Attachment 2. POLA comments on the “Los Angeles-Long Beach Harbors and San Pedro Bay Hydrodynamic and Sediment-Contaminant Transport Model” developed by Tetra Tech, Inc. for USEPA Region 9

Detail Comments on Draft “Los Angeles-Long Beach Harbors and San Pedro Bay Hydrodynamic and Sediment-Contaminant Transport Model Calibration” prepared by Tetra Tech, Inc. for USEPA Region 9, May 2008.

Detail Comments on Presentation on “Los Angeles and Long Beach Harbors and San Pedro Bay Modeling” by Tetra Tech on June 30, 2008

Figure 1 – Comparison of EPA and WRAP Model Salinity Scatter Plots

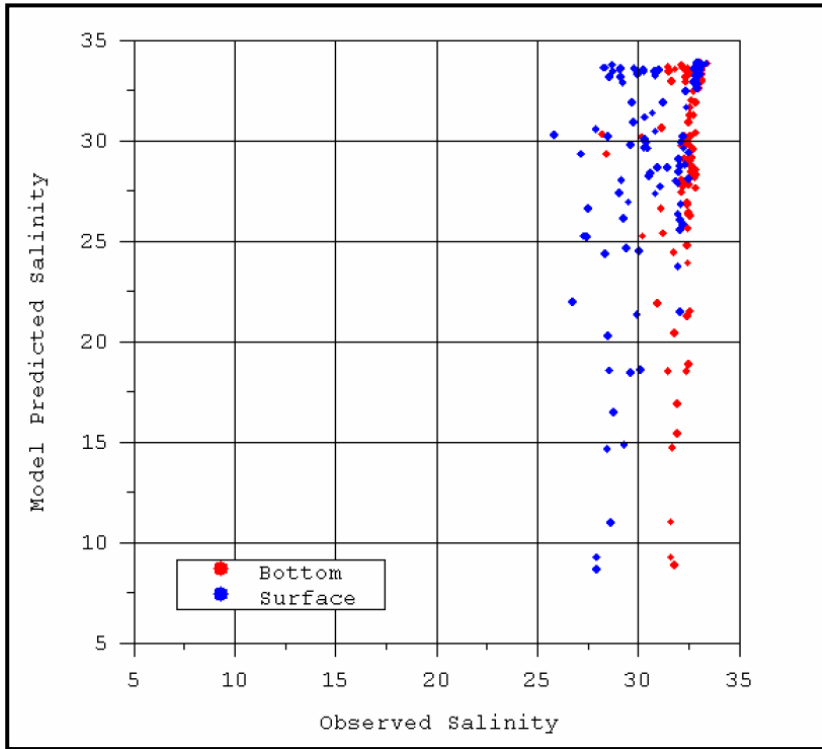
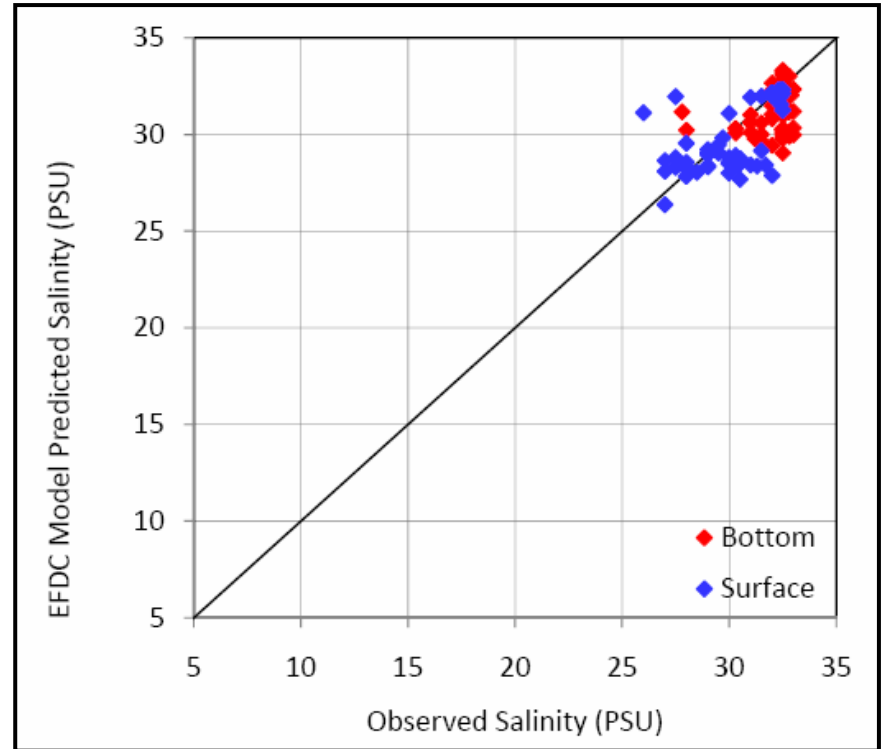
We recently used the preliminary WRAP model to simulate the 2005 salinity calibration period of the EPA model. A direct comparison of the EPA and WRAP models was not possible because the EPA model calibration report does not include information regarding the station numbers. However, comparisons were made based on model-predicted ranges in salinity levels. To do this, we randomly paired observed salinity levels with stations and also generated a predicted value for each station. A comparison of the EPA and WRAP model scatter plots are shown in Figures 1a and 1b, respectively. While field data shows a difference between surface and bottom salinity (stratification) during the rain events, the EPA model predicts similar surface and bottom salinity (i.e. no stratification). Despite the assumptions in location and timing of the salinity observations, the WRAP model shows a better match to the range of observed salinity levels than the EPA model. This exercise illustrates that better comparison between model-predicted and field measured data can be achieved when incorporating the recommendations we have made (i.e. improved hydrodynamic calibration and incorporation of publicly available wind data).

7. The model under predicts the salinity at the 20 locations in the harbor where field data are available. In some cases, the under prediction is severe and would have implications for the mass balance of fresh water (and potentially contaminants) entering the system. We recommend careful attention to resolving this issue so that errors are not carried forward. In addition, while the field data showed some stratification in the system (i.e., lower salinity at the surface than the bottom), the model predicts the water column to be well mixed (i.e., surface salinities are similar to bottom salinity). Therefore, we believe that further calibration with additional salinity data such as data collected from the DCEMS, which includes wet weather salinity data, should be performed to improve the predictive ability of the model in terms of overall level of under predictions and the high level of predicted vertical mixing.
